TECHNICAL SHEETS FOR COORDINATION

VERTICAL RECOMMENDATION FOR USE SHEETS (RfUs) - Status in March 2022

Figure 1

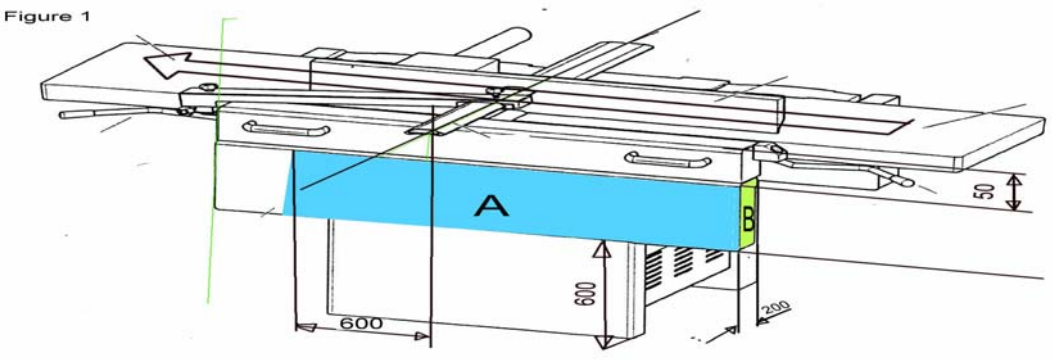
1) Is the "infeed side" in the beginning of clause a) identical with the "infeed side of the thicknesser" mentioned later on?
2) How to verify the requirement in a) that the control actuators shall be reachable from the infeed side of the thicknesser?

1) It is not clear what is really meant. The goal of the requirement is to satisfy the essential safety requirements of Directive 98/37/EC, Annex I, 1.2.2. It is required that operating the control actuators shall be possible from all working positions of the operator. This is achieved by positioning the control actuators as described in answer 2).
2) It is not clear enough to require only "reachability" of the control actuators. The actuators shall be reachable with regard to ergonomic principles. This is fulfilled when for the planing mode the control actuators for starting, normal stopping, emergency stop, powered table adjustment are located in area A or B shown in fig. 1.

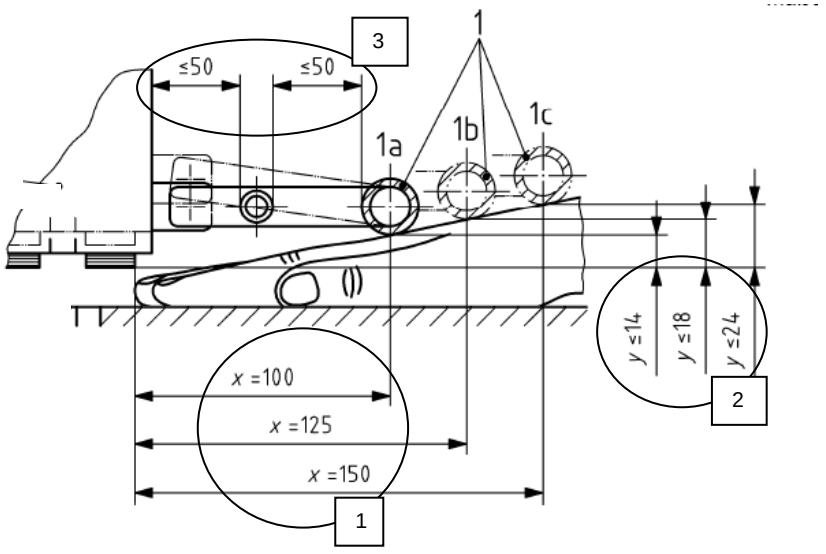
b) If a mechanically actuated trip bar is provided, is it acceptable to differ in design and dimensions from the shown figure?

[2].: Dimension Y in figure 5 is of no relevance. It relates to the contact path of the trip bar, which can be individually designed by the manufacturer, as long as the functional requirements are fulfilled.

[3] : The given dimensions of figure 5 originate from rules, stated by the Holz-Berufsgenossenschaft in 1981 for single saw blade machines with pressure beam. The first machines of this kind normally did not have a safety curtain and the pressure beam was reachable from both sides. Therefore the cutting area was easily accessible even when the pressure beam was in closed position resting on the workpiece. The lateral bars with a distance from max. 50 mm to each other should prevent the access to the pressure beam and the cutting area from the top side. However, this dimension is not in accordance with the current requirements of EN 13857:2008 table 4 any more. With the commencement of EN 1870-13:2007 a safety curtain became mandatory. With this curtain the lateral bars are not necessary any more. They can or cannot be realised.

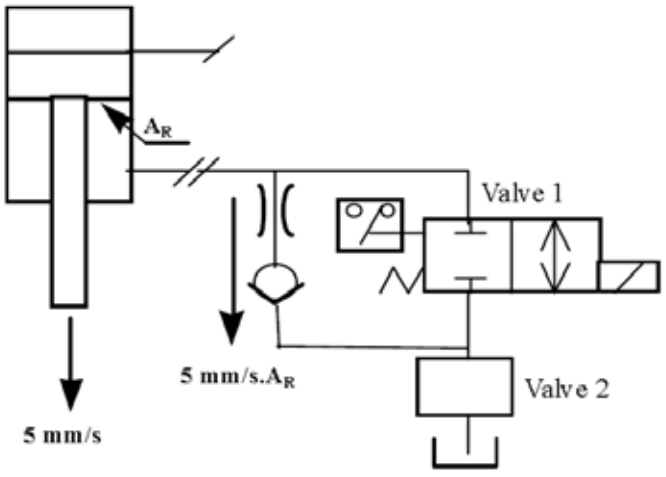
Question:
Under which conditions bypassing a restraint valve is allowed?

Solution:
1) The volume flow in the bypass shall be restricted to the value of 5 mm/s x A_R (ring area) of the cylinder, e.g. by a bleed (orifice plate)
2) The check valve in the bypass can fail without any detection (see figure)
3) If the second restraint valve fails also, the speed (leckage speed) of the beam/slide/ram shall not increase more than 5 mm/s (check valve failed already without detection)
Note: The max. weight of slide/ram/beam with
tools has to be taken into consideration

Figure 1

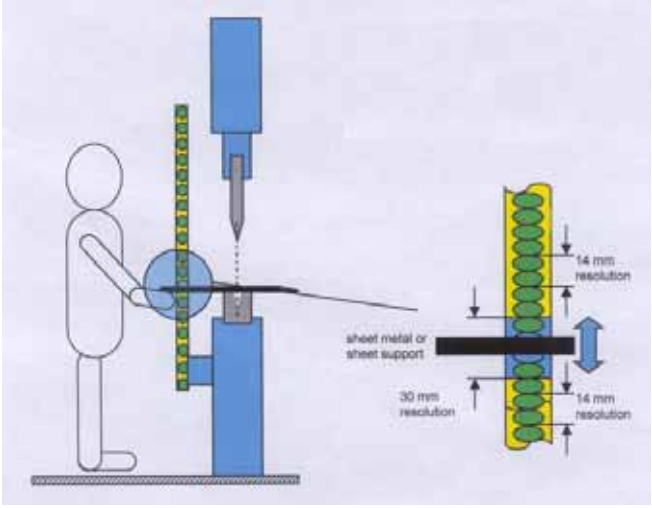
Question:
On press brakes fitted with light curtains it is often necessary to blank out partial areas (see figure 1) of the protection field only for making invisible the work-piece supports.
Is it in this case obligatory to correct the safety distance between the protection field and the danger spot?

Answer:
It is not obligatory to correct the safety distance (see figure 2) when blanking if the following conditions are fulfilled:

- The resolution of the light curtain at the blanking point shall be ≤ 30 mm; means shall be provided to prevent the user from reprogramming the safety interface;
- The resolution in the rest of the area shall be 14 mm;
- The safety distance shall be calculated as described in Annex A of EN 12622:2001, using a resolution of 14 mm;
- The safety distance shall be ≥ 150 mm;
- It shall not be permitted to initiate cycles using the light curtain;
- There shall not be more blanking areas than necessary for making invisible the sheet supports;
- The manufacturer has to incorporate a warning into the operator's instruction manual to make him aware of the different resolutions in the two areas.

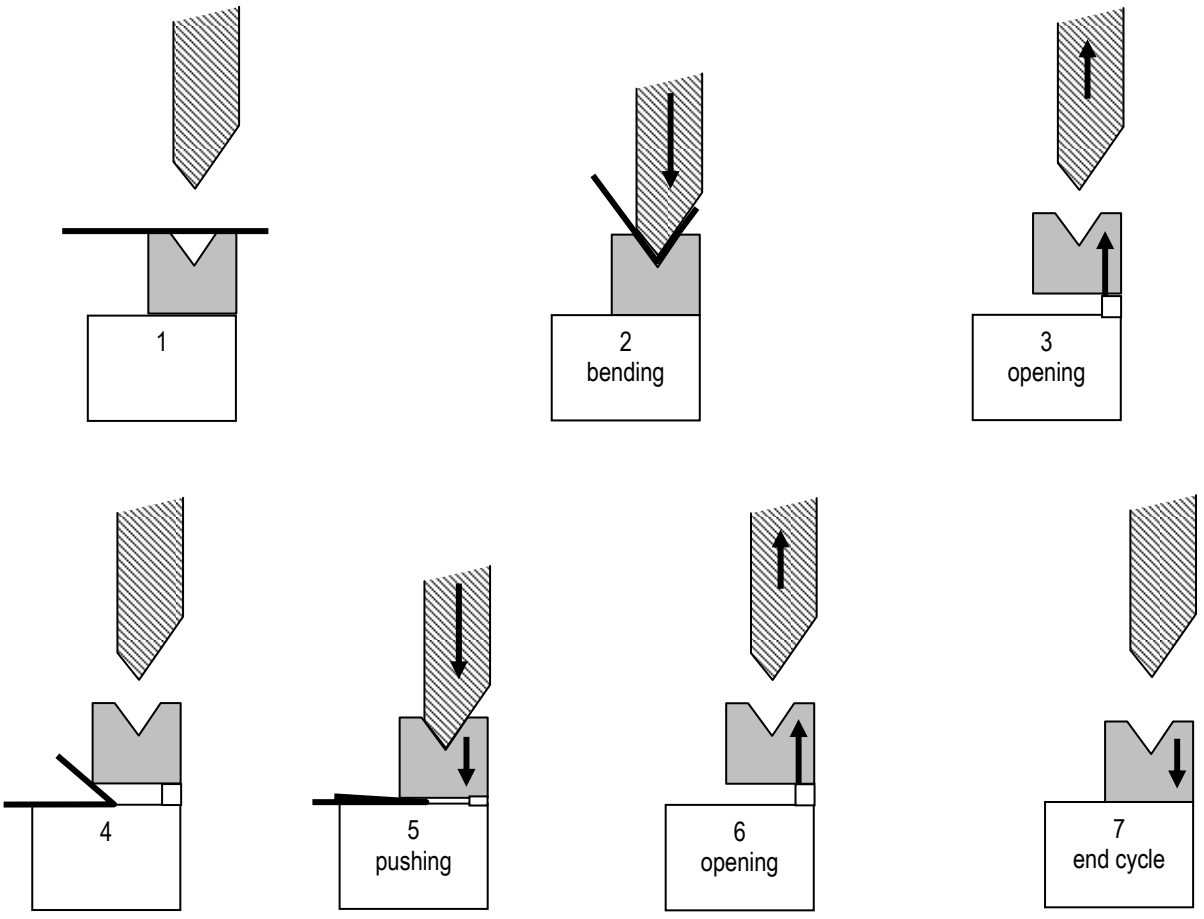
Some press bakes are equipped with secondary devices (e.g. bend and push devices) which don't stand in he bending zone but can use the down stroke movement to perform the operation. This equipment is usually pneumatic with at least two single effect cylinders.

What should the safety devices of this secondary working part be?

This type of tool has two danger zones. The first danger zone (a) is between the main tool and secondary tool and the second danger zone (b) is underneath the secondary tool.

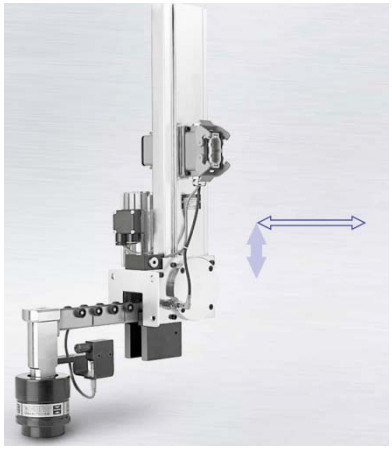
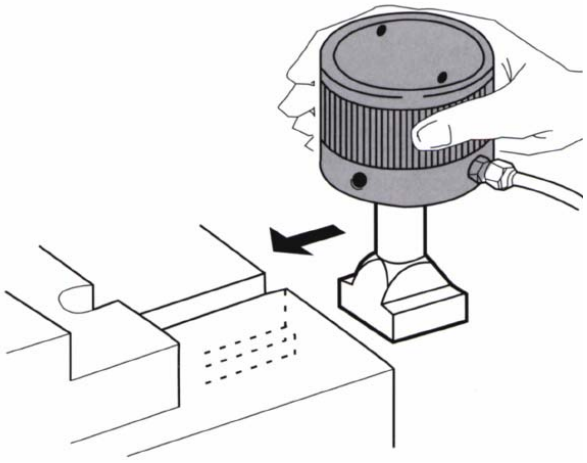
Clamps are integrated in the slide (see fig. 1)

Clamps are manually positioned (see fig. 2)

If the clamping stroke is higher than 6mm (EN ISO 13857:2008)

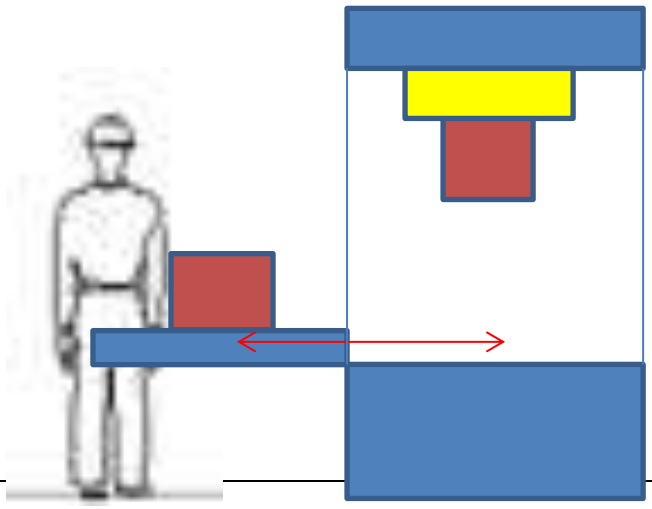
The work piece is manually placed on the lower die, which has been slid outside of the danger zone. When the work cycle starts the lower die first slides inside the danger zone and when in position the upper die moves downwards

Are these machines included in annex IV?

NO: if the slide is an integrated auxiliary device of the press (the operator can only place the work piece outside the danger zone)

Figure 1 asymetric post lift

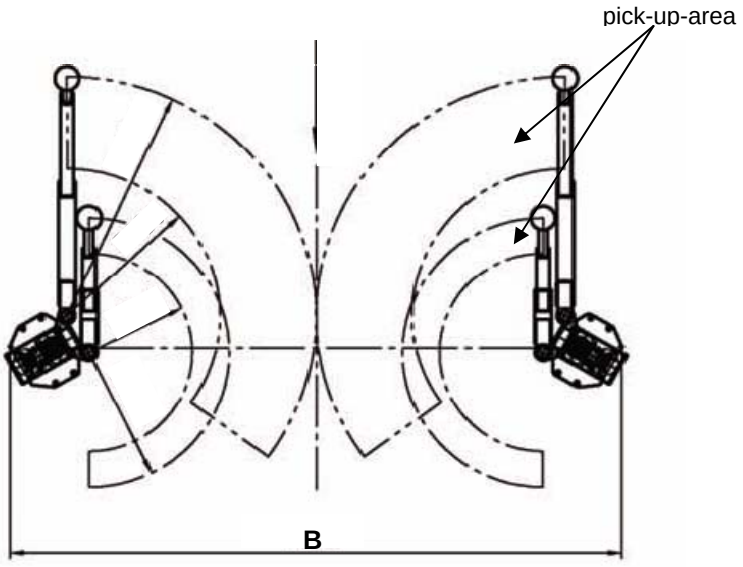
The standard requires that the long arms must be in the maximum telescoped position with a width of 1 m of the pick-up points. The short arms should be "in the position which gives the worst condition".
Normally, vehicles are raised so that the center of gravity is close to the connecting line between the two lifting columns.
But there are many vehicle servicing lifts where it is possible to raise a vehicle with all four arms pivoted in the same direction (see figure 1).
Especially at asymmetric two post lifts or lifts with double swing arms, it is possible, to reach such a position and to lift vehicles.
